WALKER
ENGINEERING
CONSULTANTS

WECL Project Reference: 24106

Description: Proposed Extensions & Upgrades of an Existing Dwelling – Stormwater Aspects

Subject: Response to Request for Information 03 – Engineering Aspects

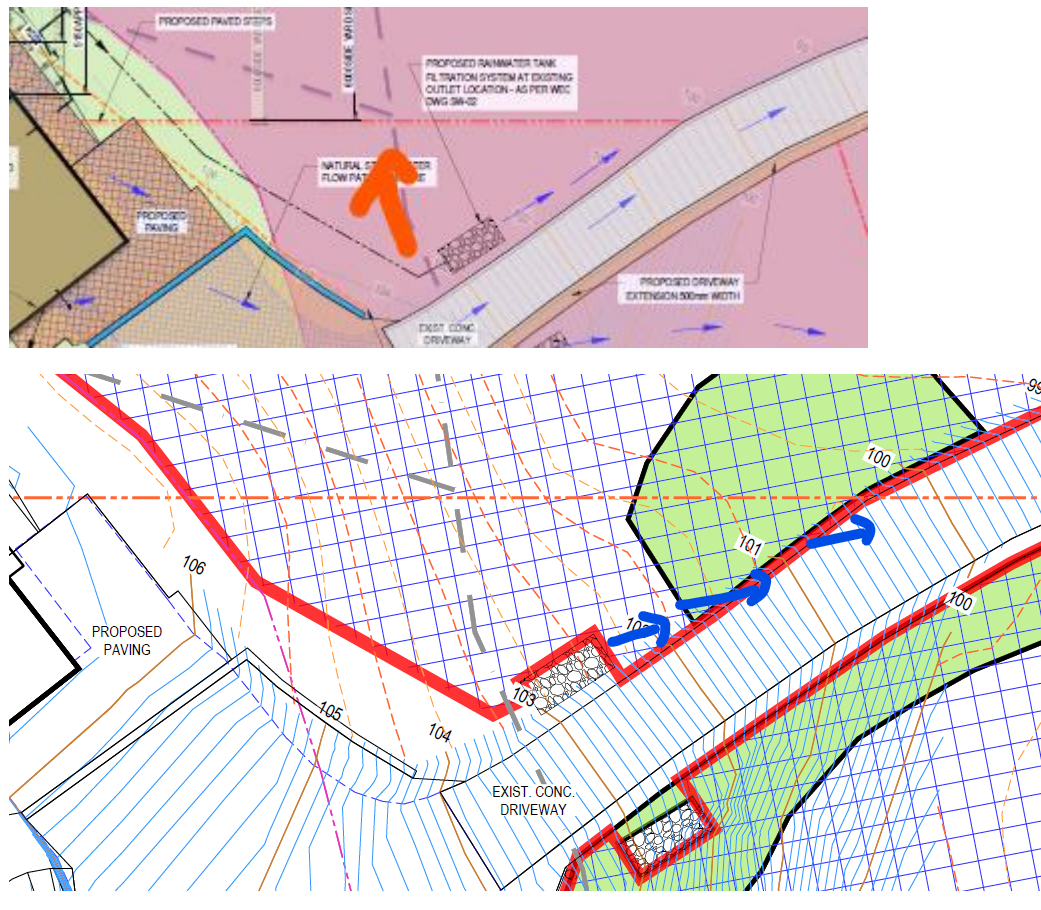
2. The design of the on-site stormwater piping and tanks is different between the architectural plans (Proposed Site Plan) and the stormwater mitigation report (stormwater system markup of the proposed site plan). The main difference is the discharge of stormwater to the west (site plan) or east (stormwater markup). Additionally, please provide additional assessment to demonstrate that discharge of stormwater from the proposed outlets, but in particular at the top of the site, meet the general standards under E8.6.1, including that they will not cause or increase scouring or erosion at the point of discharge of downstream, or damage to other properties. The differences is with regard to this T-bar, which isn't present on the archi plans:

Engineer Response: We agree that the T outlet for the subsoil drainage behind the retaining wall (low catchment) was not captured on the architectural drawings. The architectural plans have now been updated accordingly to align with the stormwater design.

Regarding the stormwater layout, the stormwater assessment reflects the intended design, including discharge direction. The new impermeable areas at the top of the site are collected and diverted to a detention tank system located below the deck. The controlled discharge from this system is limited via a low-flow orifice, with peak outflows below 1.1 L/s as outlined in the stormwater report.

These low flows are then directed to the riprap system, which provides localised energy dissipation and spreading of flow, as outlined in response to Point 1. Given the low controlled discharge rate and resulting low velocities, the potential for scouring or erosion at the discharge point is considered minimal.

Overall, the proposed system results in a reduction in peak discharge compared to the existing site (1.24 L/s), and therefore will not increase erosion potential or cause adverse effects on downstream areas or neighbouring properties. The design is therefore considered to meet the intent of E8.6.1 in terms of avoiding adverse effects such as scour, erosion, or damage to other properties.
